<b>AMENDMENT OF SOLICITATION/MODIFICATION OF CONTRACT</b>			1. CONTRACT ID CODE		PAGE OF PAGES 1   6		
2. MODIFICATION NO.:  0001		3. EFFECTIVE DATE  JUN 03, 2005		4. REQUISITION/PURCHASE REQ. NO.  W81W3G-2035-7181		PROJECT NO. (If applicable)	
6. ISSUED BY Department of the Army Baltimore District, Corps of Engineers Contracting Division P.O. Box 1715 Baltimore MD 21203-1715		CODE CA31		7. ADMINISTERED BY: Contracting Division, Contracts Branch CENAB-CT-C 10 S. Howard ST. Room 7000 Baltimore, MD 21203-1715		CODE E1P0100	
8. NAME AND ADDRESS OF CONTRACTOR (No., street, county, State and ZIP Code)				(x)		9A. AMENDMENT OF SOLICITATION NO. W912DR-05-R-0051	
				X		9B. DATED (SEE ITEM 11) MAY 19, 2004	
						10A. MODIFICATION OF CONTRACT/ ORDER NO.	
						10B. DATED (SEE ITEM 13)	
CODE		FACILITY CODE

**ADAL BALLISTIC TESTING FACILITY  
ICE, ALTOONA, PENNSYLVANIA**

AMENDMENT NO. 0001 TO RFP W912DR-05-R-0051  
EFFECTIVE JUN 03, 2005

**A-S-1**

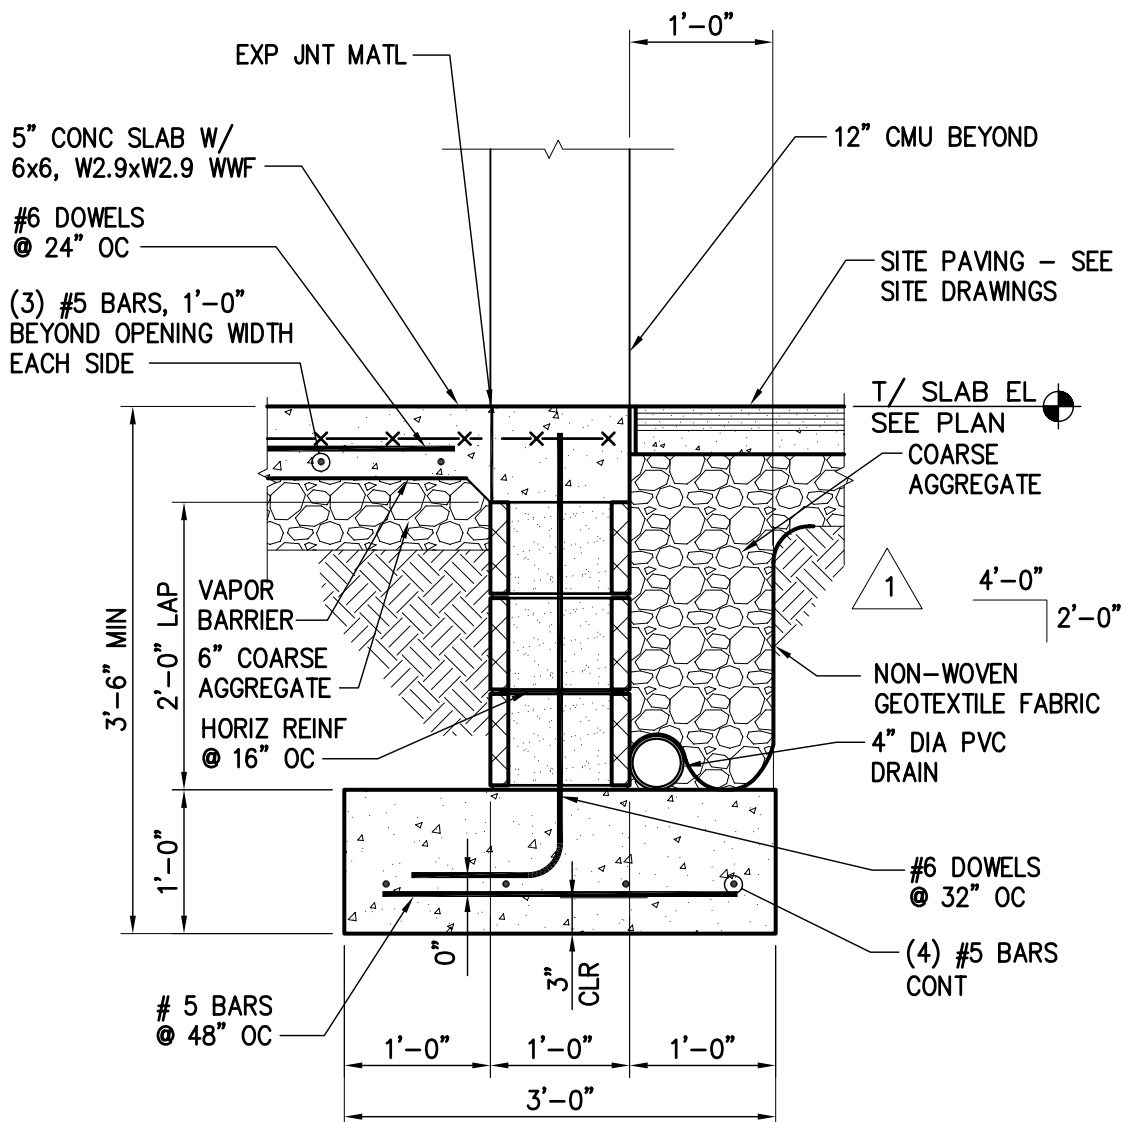
- b. Revise Plate in accordance with the attached Sketch A-S-1, dated May 27, 2005.
  - c. Relocate turn-down slab outside of Door 101 to coordinate with Architectural change. Slab shall begin 4'-8" from the exterior face of CMU at the north wall.

Dwn by: RME	Design file no. 2003-0217.02	Scale: AS NOTED
Ckd by: DM	Drawing Number: F-178-14-01	Sheet Number:
Submitted by: JCK	Date: 27 MAY 05	<b>A-S-3</b>

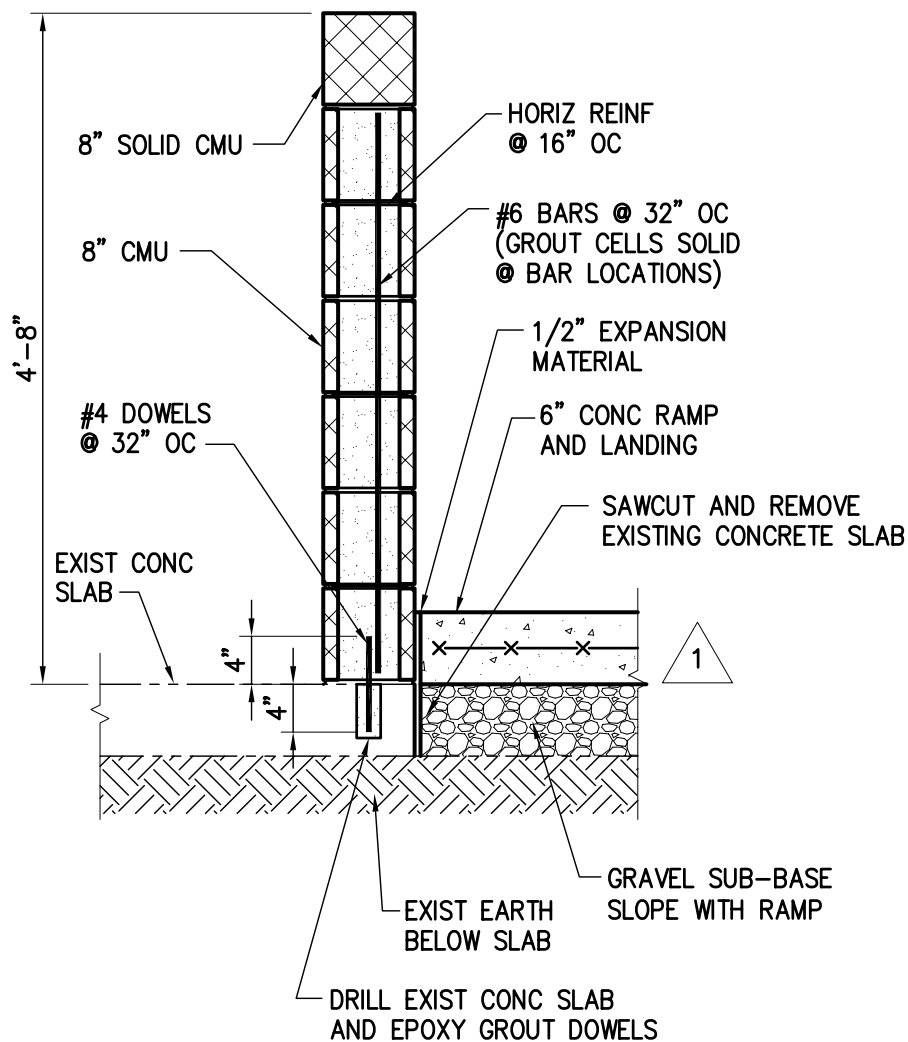
- b. Section 9 – Revise section in accordance with the attached Sketch A-S-3, dated May 27, 2005.
- 10) Plate 13, Framing Sections and Details: Change the following items:

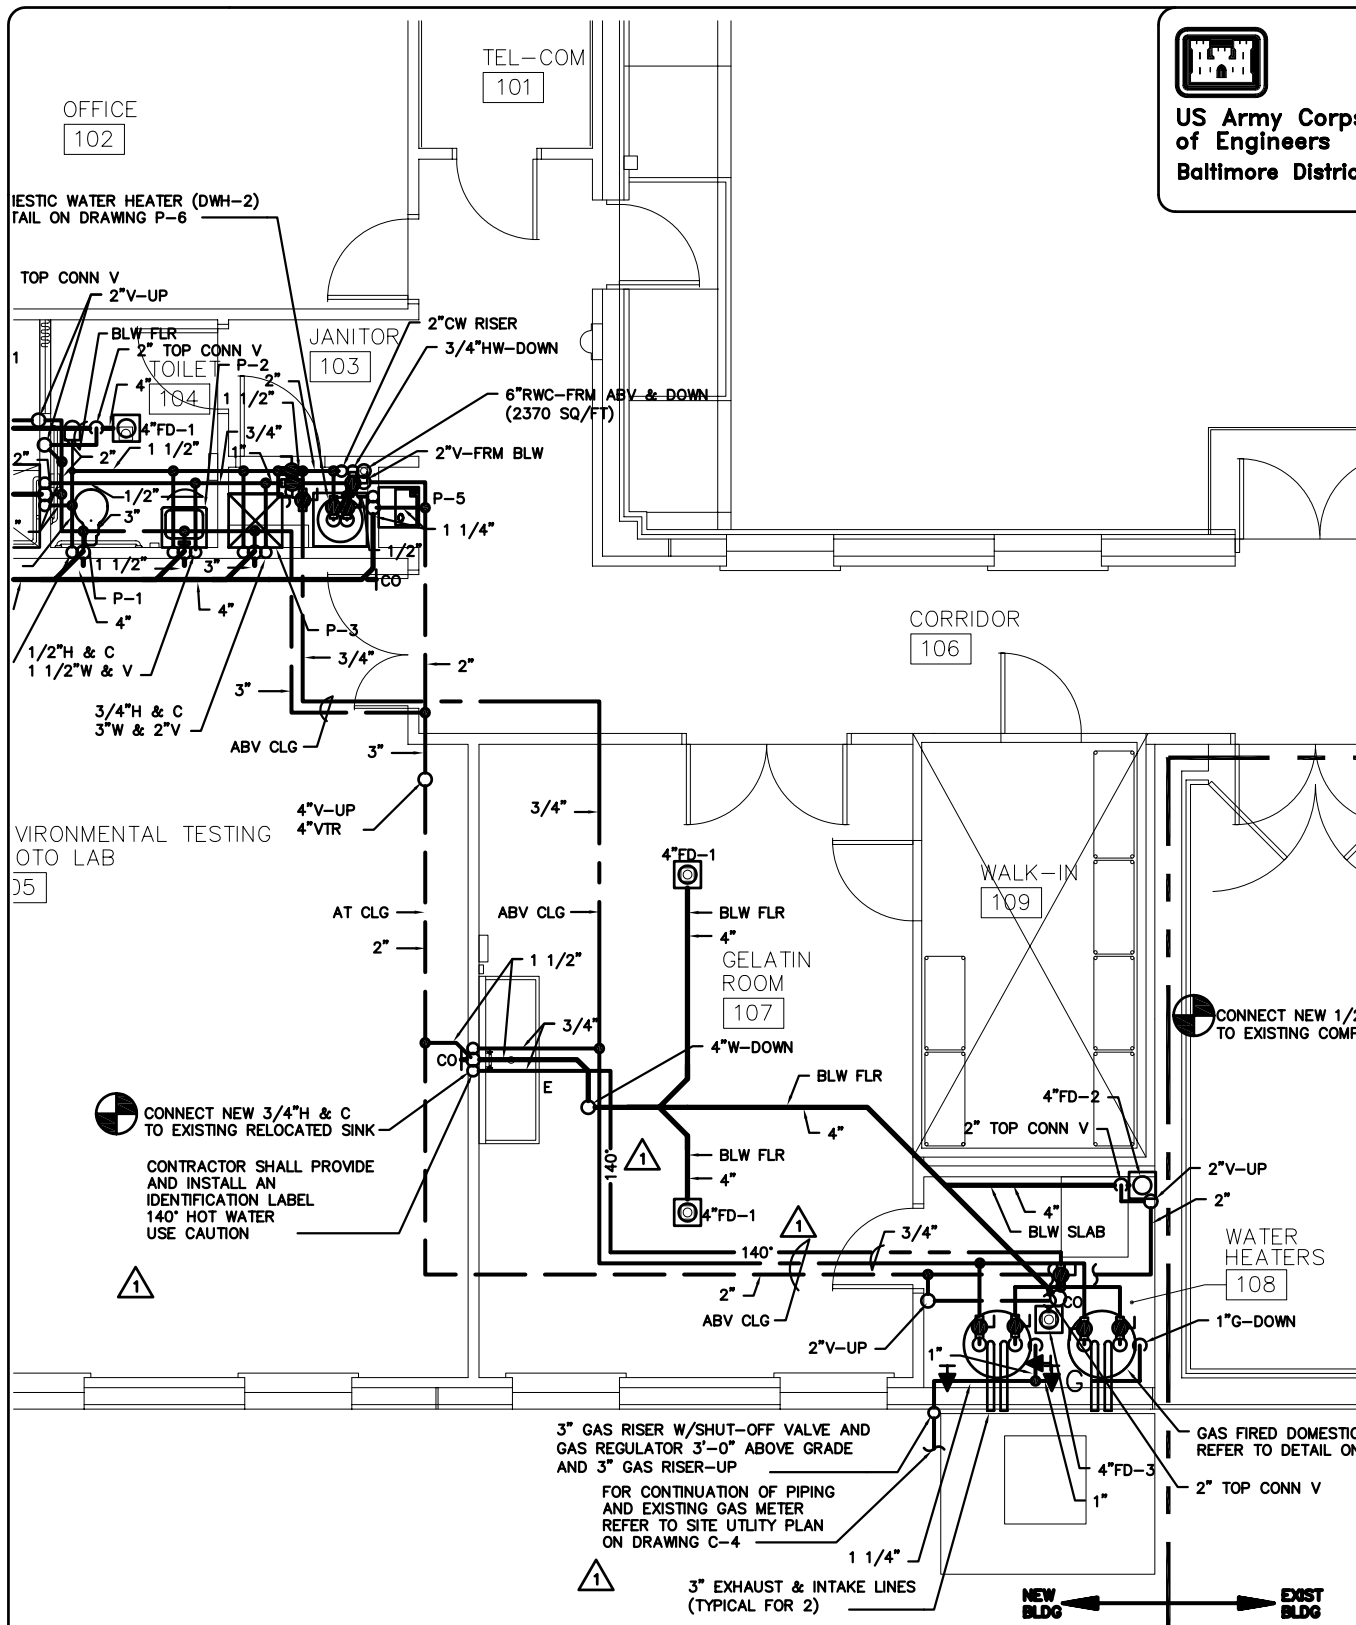
- 23) Plate 33, Basement Floor Plan – Plumbing: Revise in accordance with the attached Sketch A-P-1, dated May 27, 2005.
- 24) Plate 34, First Floor Plan – Plumbing: Revise in accordance with the attached Sketch A-P-2, dated May 27, 2005.

**A-P-3**

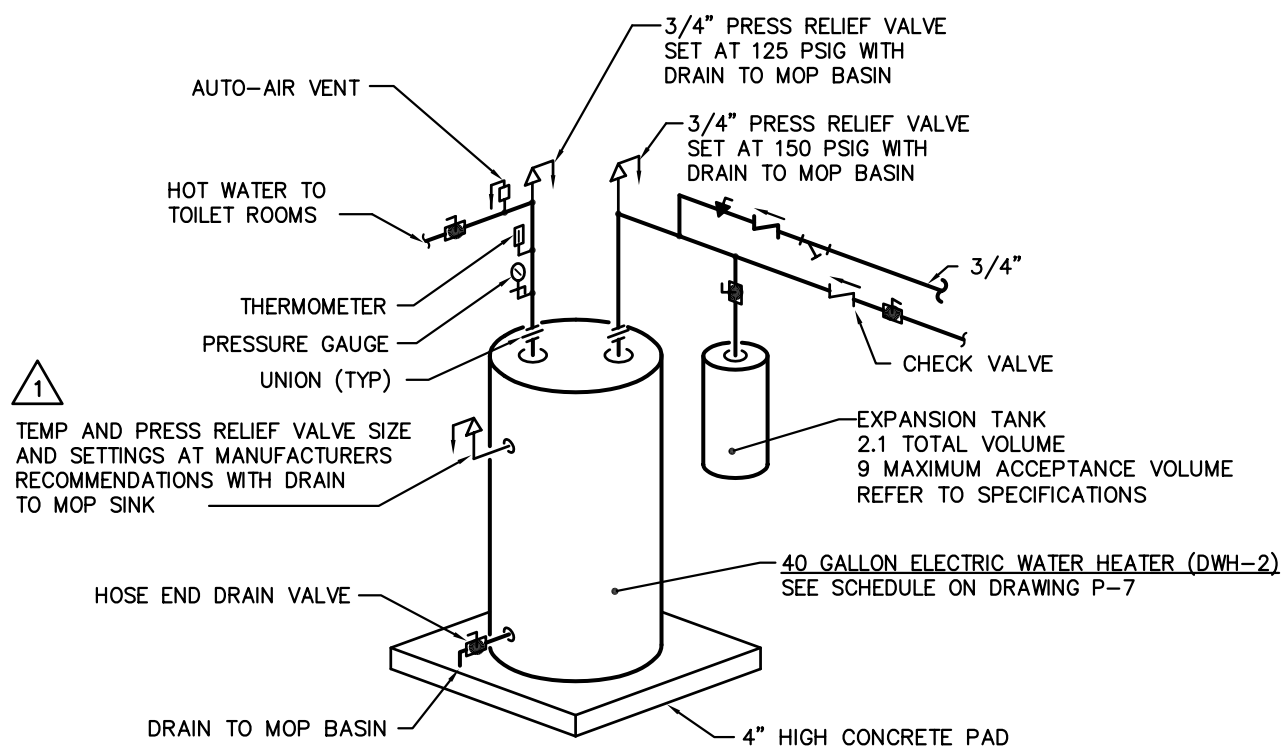
- 25) Plate 36, Details - Plumbing: Revise details in accordance with the attached Sketches A-P-3 and A-P-4, dated May 27, 2005.
- 26) Plate 37, Schedules - Plumbing: Revise in accordance with the attached Sketch A-P-5, dated May 27, 2005.

A-A-1

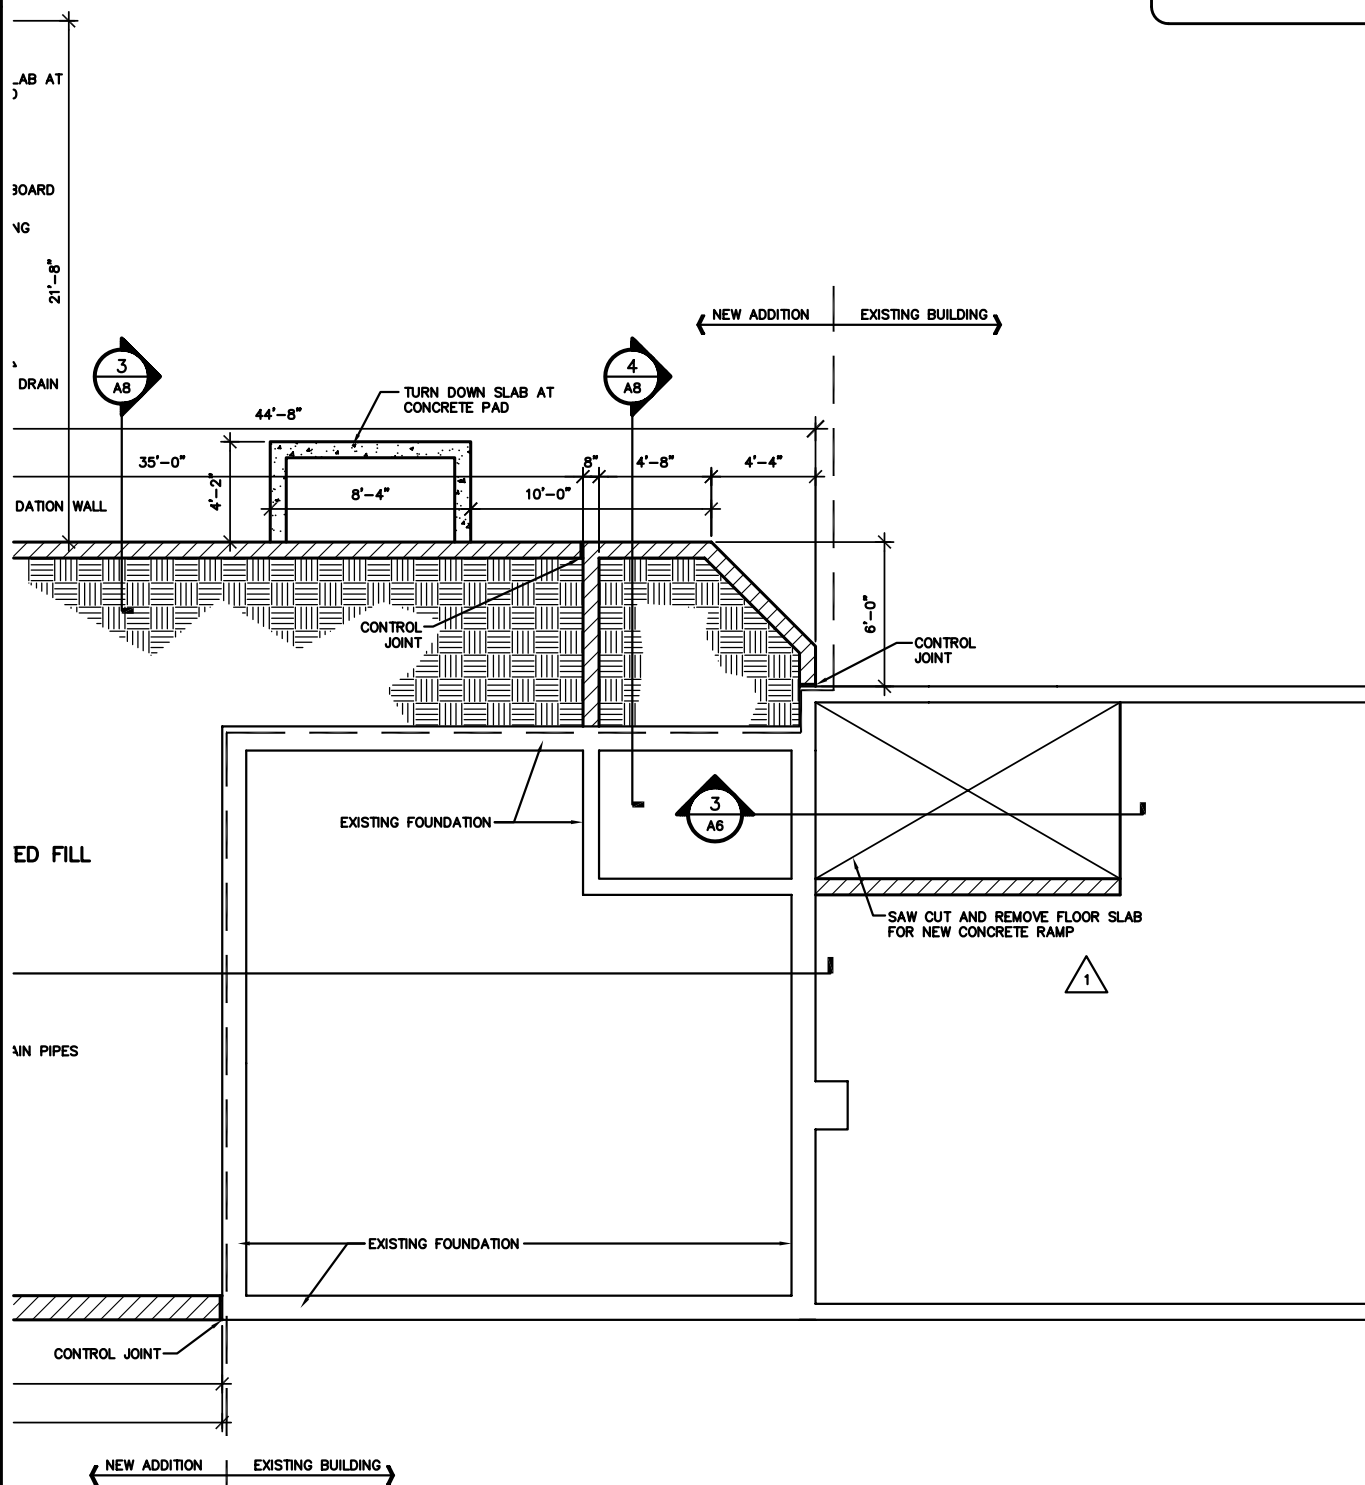
- 13) Plate 17, Basement Plan: Change the following items:
- a. Basement Floor Plan – Revise plan in accordance with the attached Sketch A-A-1, dated May 27, 2005.

A-A-2

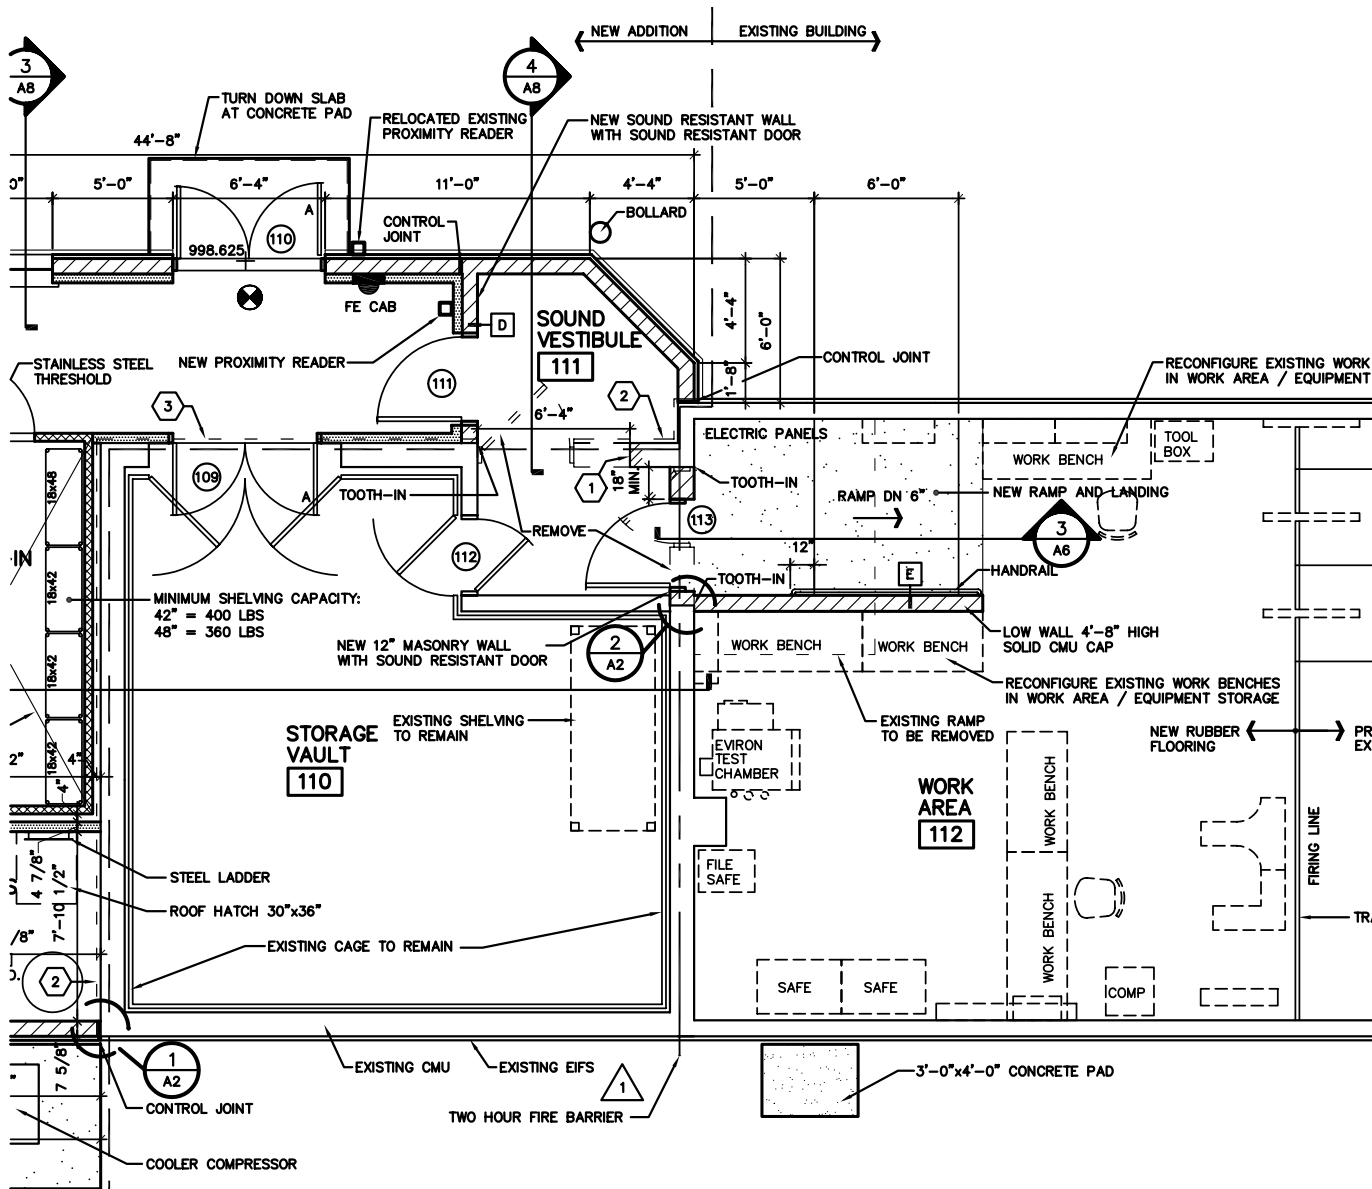
- b. Basement Floor Plan - Revise plan in accordance with the attached Sketch A-A-2, dated May 27, 2005.
  - c. Basement Floor Plan – Deleted note for filter fabric wrap on 4” perforated drain.
